Access Compliance Report Public Rights-of-Way (Curb Ramps)

Main Street: COLCHESTER_DR Cross Street: HARVEST_LN Location: SE

ADA ID: RPRK210927144213 Ramp Type: Type 1 - Perpendicular Diagonal Initial Pass/Fail: Pass Overall Compliance: No Severity Score: 0

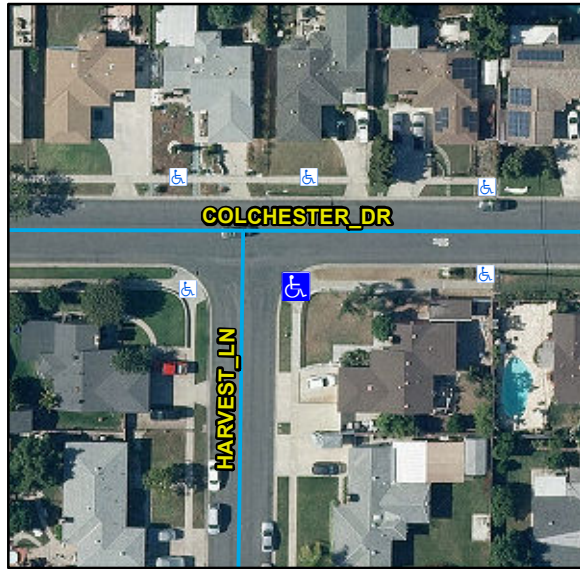
Remove & Replace Landing.

R304.2.1, R304.2.2-Perp, R304.3.2-Para, STD 1115
